# TOLEDO - LUCAS COUNTY PLAN COMMISSIONS

DATE: January 13, 2022 REF: SUP-11001-22

Special Use Permit for a CDL Driving Pad with Propane Storage

5600 Hill Avenue

LANDSCAPE PLAN

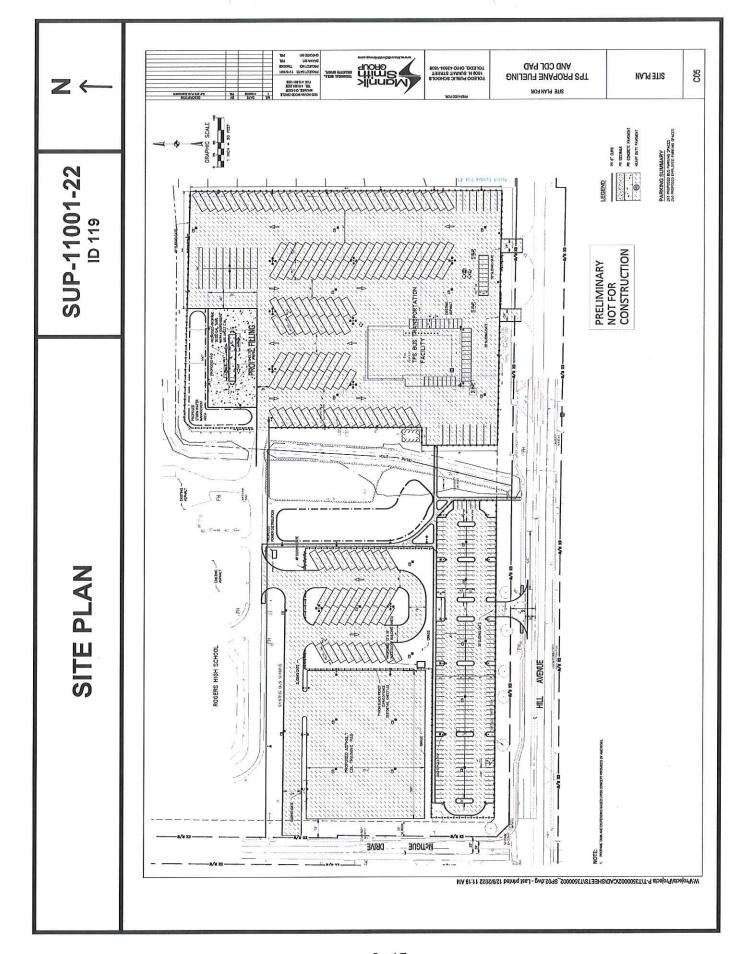
- 38. A detailed site, lighting, fencing and four (4) copies of a landscaping plan (separate from building & site plans) shall be submitted to the Plan Director for review and approval. Such plan shall include:

- a. A thirty-foot (30') greenbelt is required along each frontage, and shall include one (1) tree per every thirty feet (30') of frontage. The portion of the site with a parking lot facing right-of-way shall include a solid evergreen hedge planting to screen the parking lot so that no headlights of any vehicles can be seen from the public street. **Acceptable as depicted.**

- b. The solid evergreen hedge plantings shall be extended north along the CDL pad to screen headlights from the right-of-way. **Not acceptable as depicted**

- c. All parking areas visible from the right-of-way or adjacent properties shall be screened from view using an evergreen hedge line so that no headlights of any vehicle can be seen. Acceptable as depicted.

- d. Perimeter landscape parking is required along the eastern side of the parking lot containing at least one canopy tree must be provided for each 40 linear feet, plus a continuous shrub with a minimum height of 18 inches. **Not acceptable as depicted.** Landscaping or waiver required.

- n. A seven-foot (7') solid fence screening the eastern side of the site from neighboring residential uses. Not acceptable as depicted.
- 39. The Special Use Permit may be reviewed for compliance with the conditions of approval, negative secondary effects, and adherence to all requirements of the Toledo Municipal Code. If outstanding issues are found and not addressed the Special Use Permit may be considered for revocation.
